2nd Review

Jan 2025

EAST TOWN CROSSING FRONTAGE IMPROVEMENTS

PERMIT SUBMITTAL

To be used for E Pioneer lights Civil Plans - SL.10

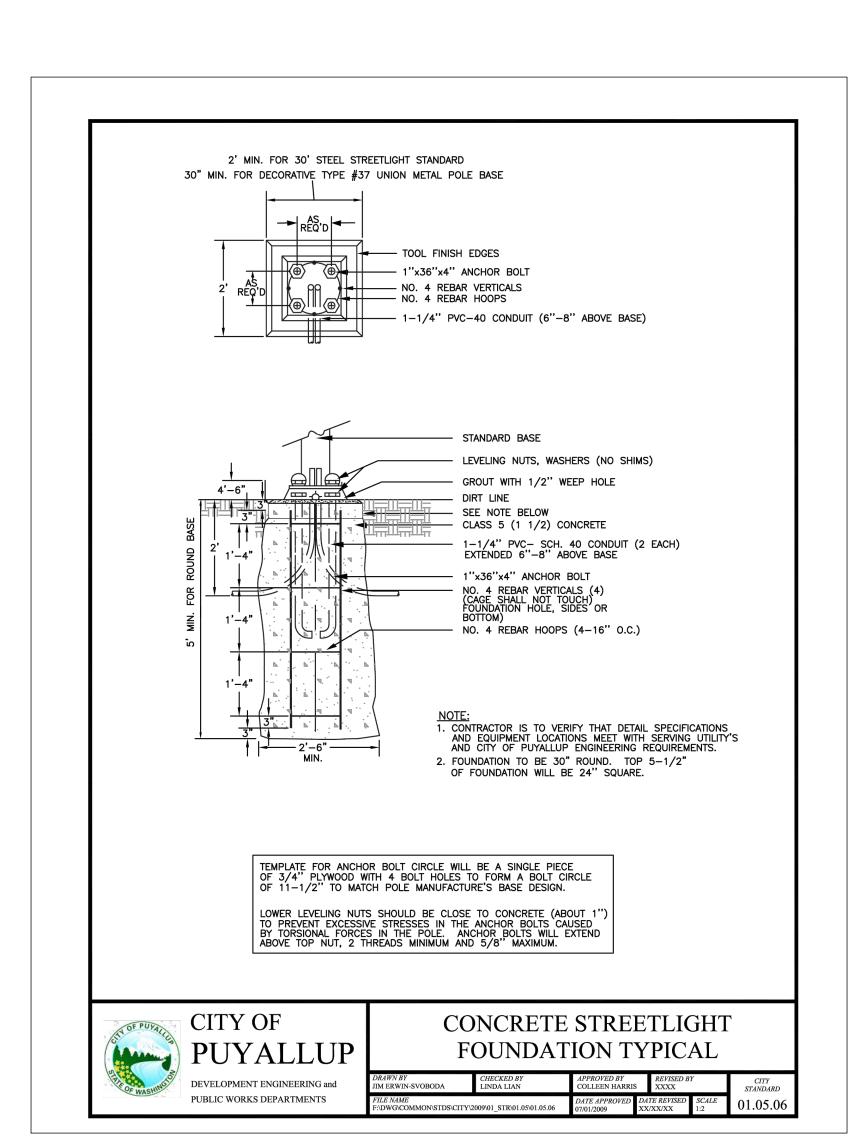
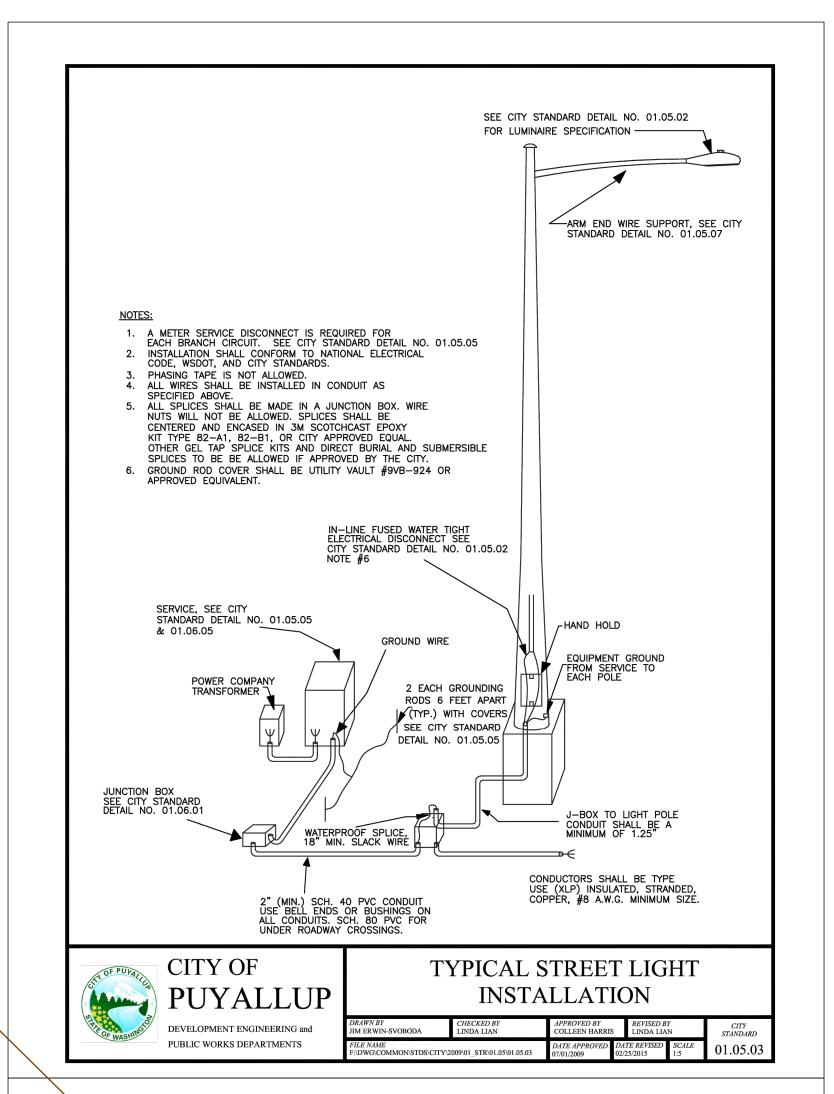
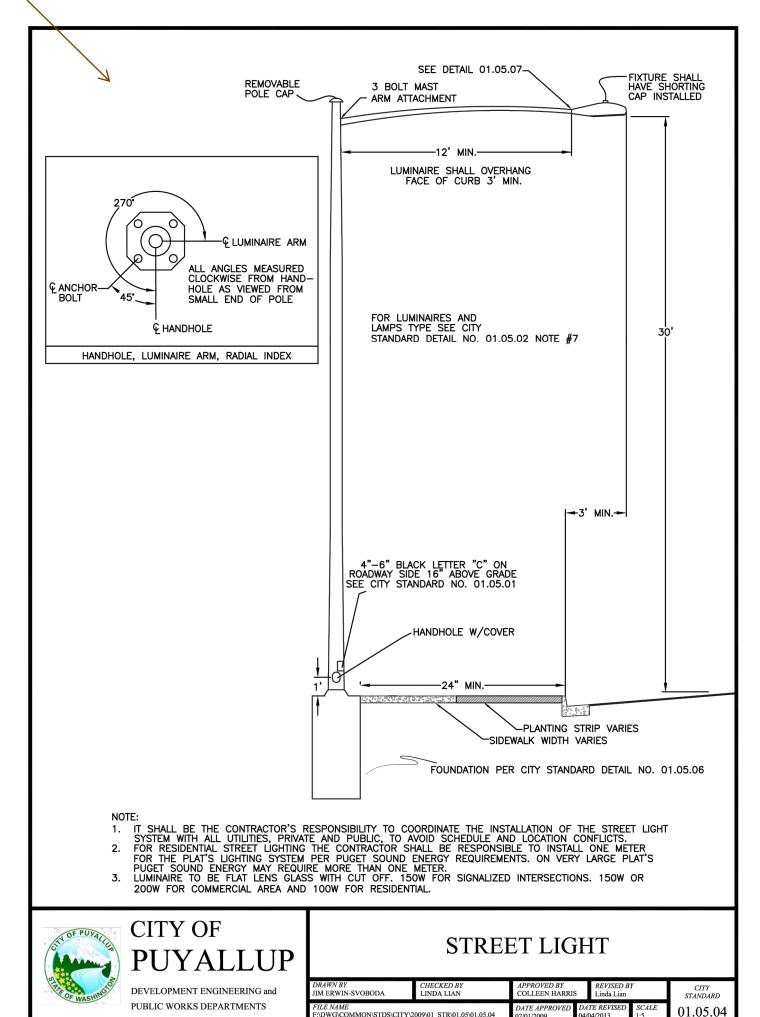
El: Is this standard still plicable for all poles sinc ne standard lists a 12' imum arm length?

TS-02 SHEET:

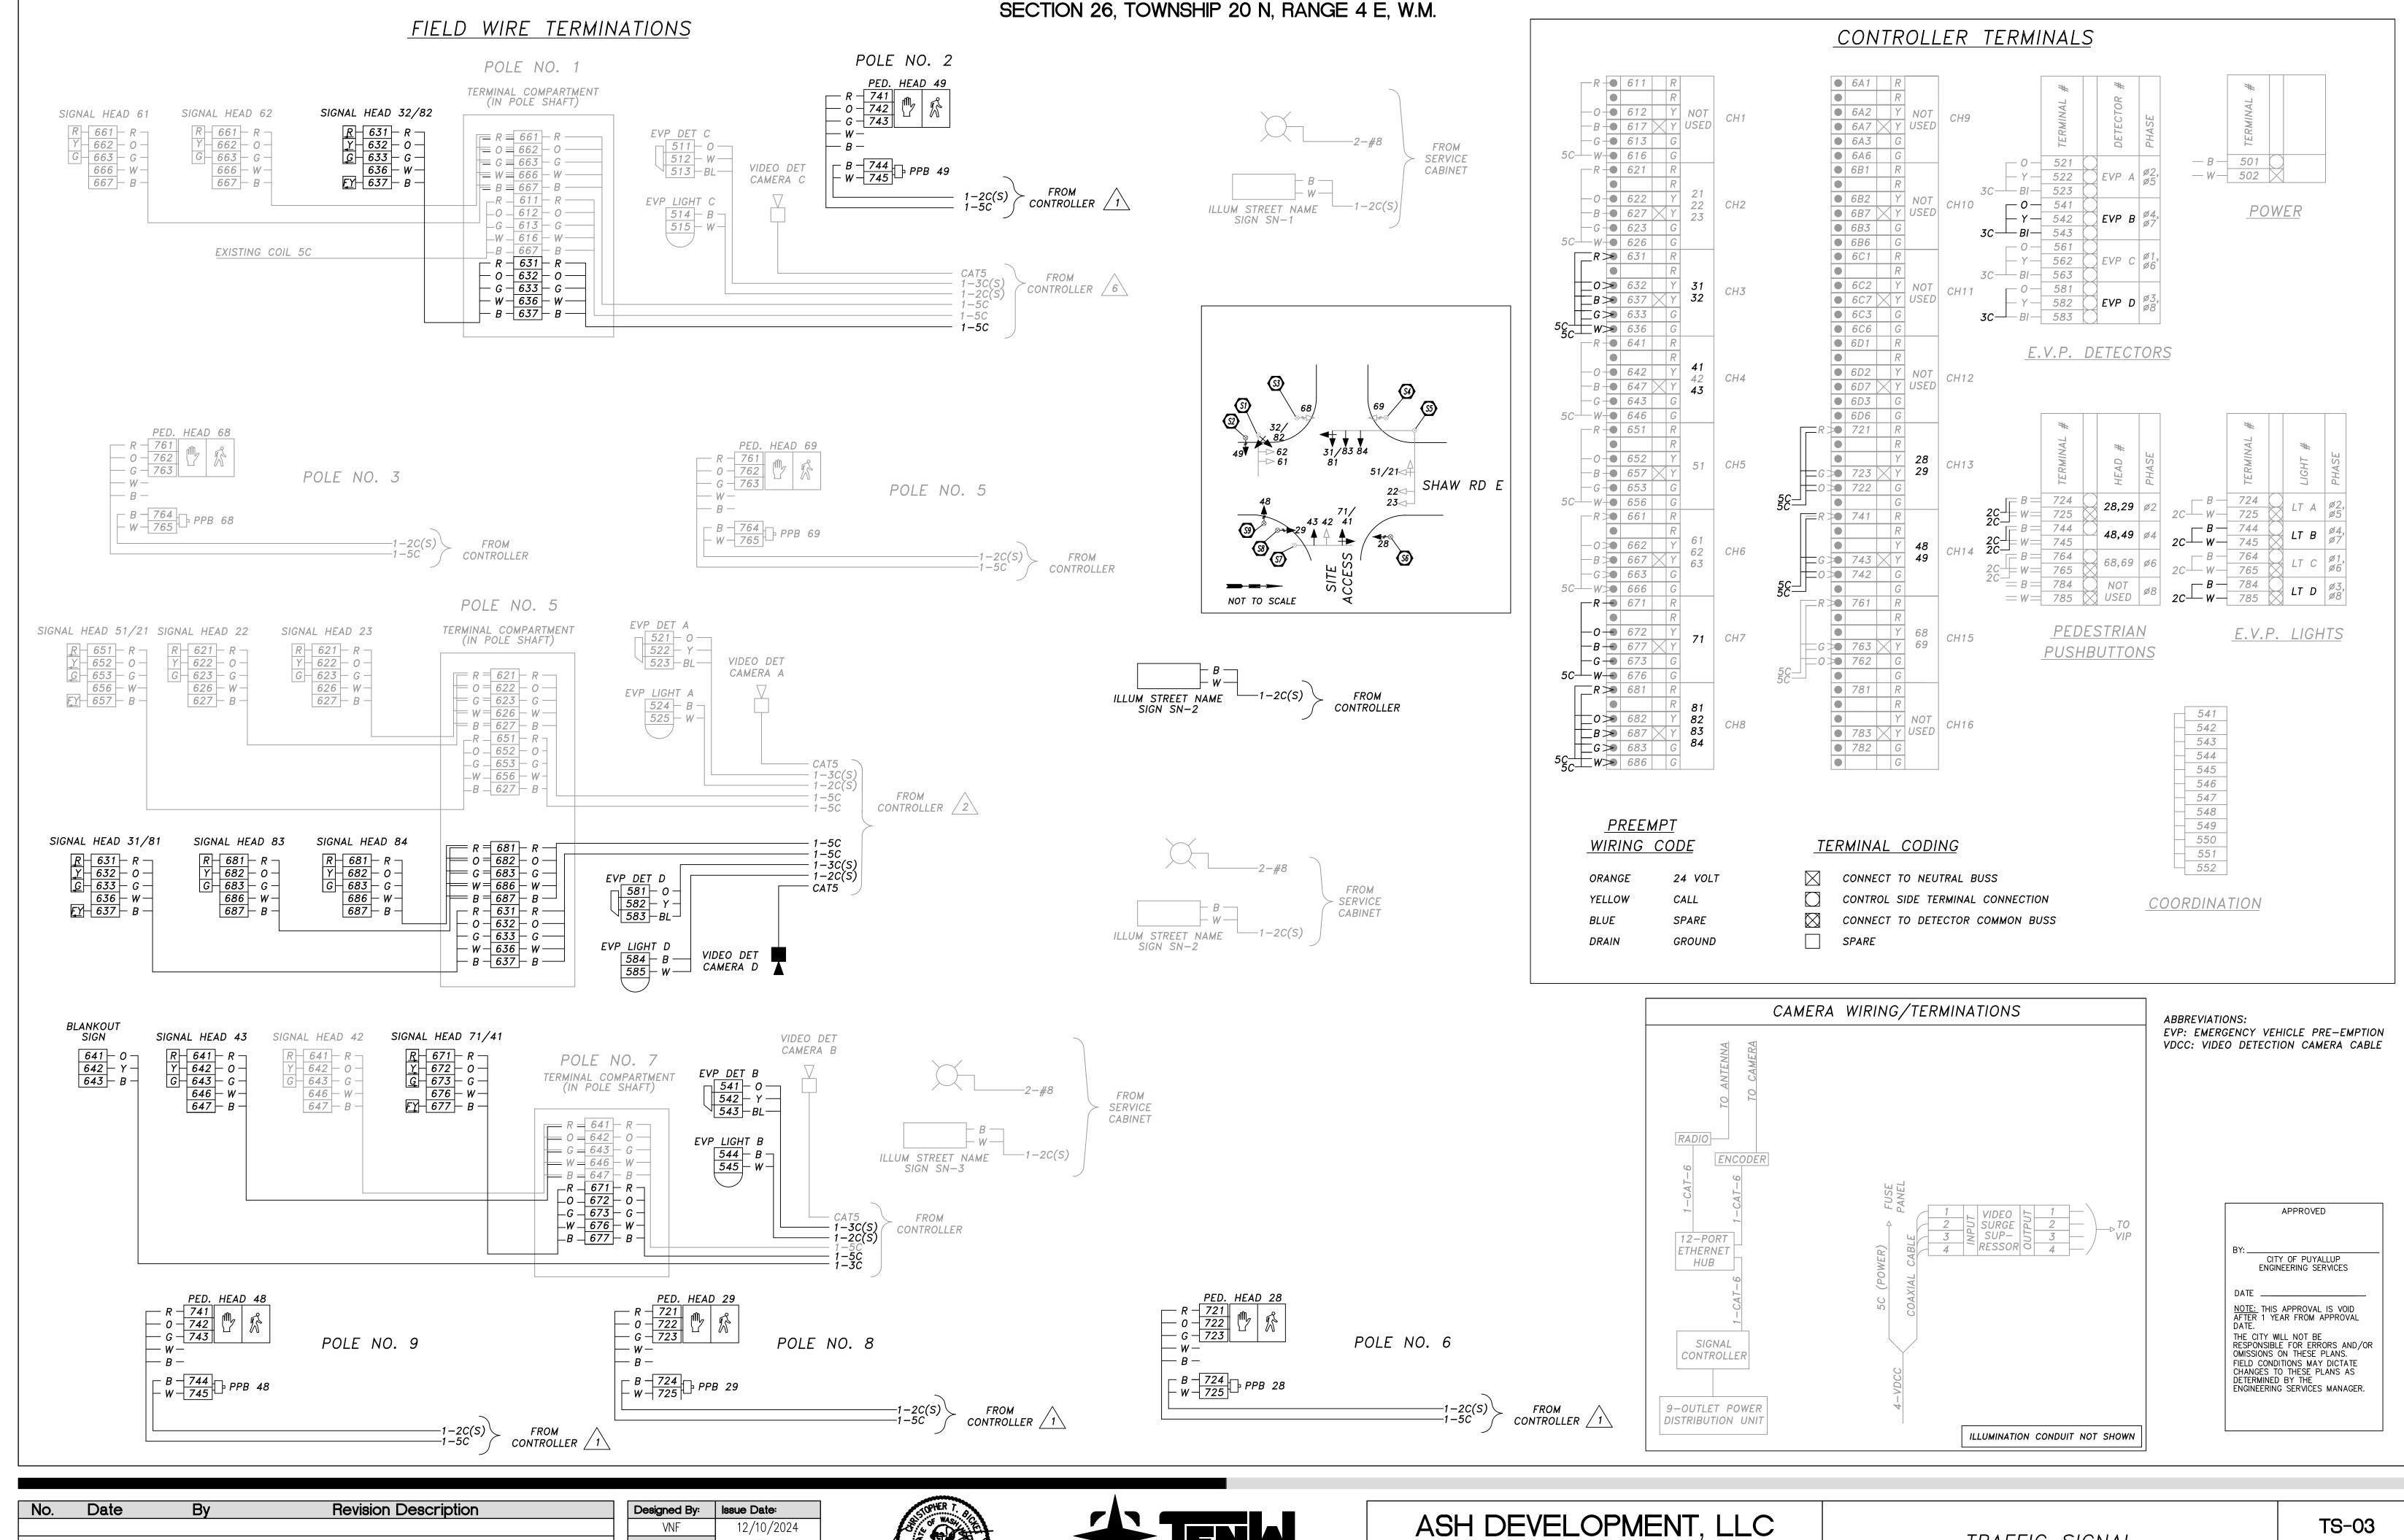
- 23. THE REQUIRED SIGNAL MODIFICATIONS MUST BE FULLY CONFIGURED AND OPERATIONAL NO LESS THAN 2 WEEKS PRIOR TO RECEIVING OCCUPANCY FOR ANY BUILDING ON-SITE. ADAPTIVE SIGNAL CONTRACTOR (RHYTHM ENGINEERING) WILL BE REQUIRED TO CONFIGURE THE ADAPTIVE SYSTEM ON-SITE.

TENW Response: Additional text added, as requested. Fully configured and operational includes adaptive configuration. overhead fiber connectivity, all intersection striping, signal hardware, signage, all on-street lighting, etc. are installed and operational. **TENW Response: Revised as** circuit TS-02
